# CYPRESS SEMICONDUCTOR

## PRODUCT CHANGE NOTIFICATION

**PCN:** 990028

**Subject:** FIFO, 3.3V, x 36, Data Sheet Change with Errata

Figure 1.

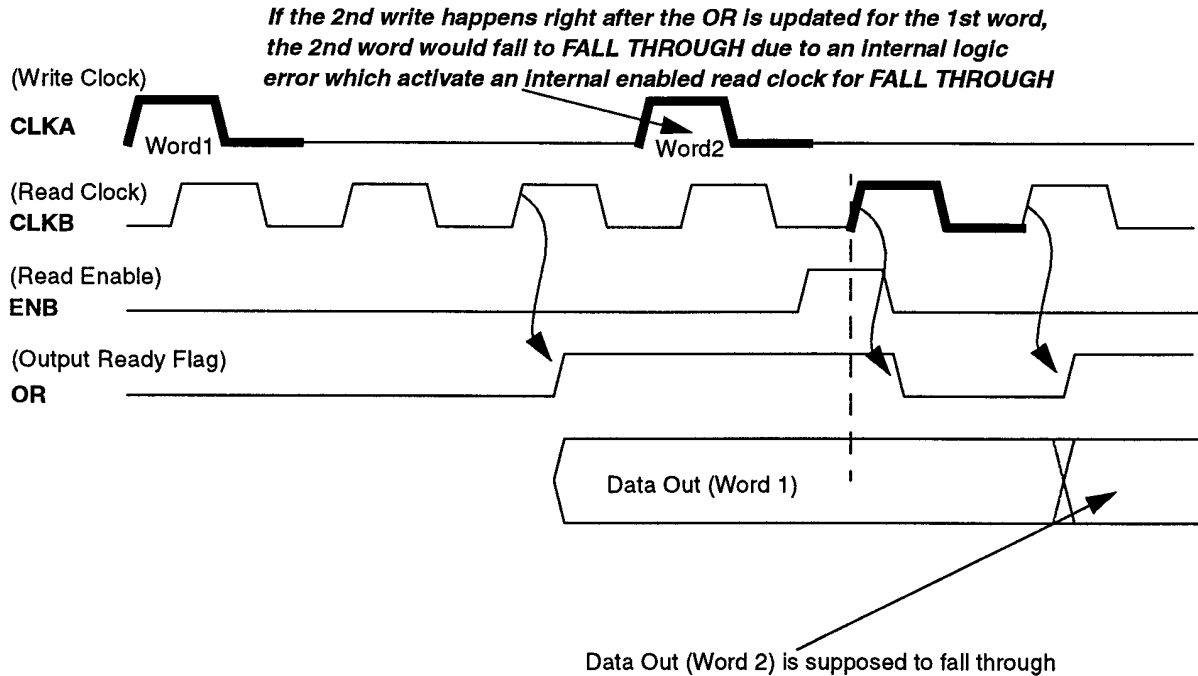
The First Word Fall Through (FWFT) mode was found to have an issue with its logic when there is only one word left in the FIFO. If a new word is written into the FIFO right after the Output Ready (OR) flag is updated when the final word in the FIFO is read, this new word will fail to fall through; a duplicate of the previous word will be at the output instead. The new word will only appear at the output at the following clock cycle. The timing diagram (figure 1) below illustrates the issue:

Note that only FWFT mode demonstrates such behavior, there is no such issue with the CY standard mode in existing parts. The permanent solution to this issue is being implemented in Rev A of CY7C436XXV and is due for release in the September time frame. Users requiring FWFT mode in their application may implement the following solution in Figure 2 until the new revision is available:
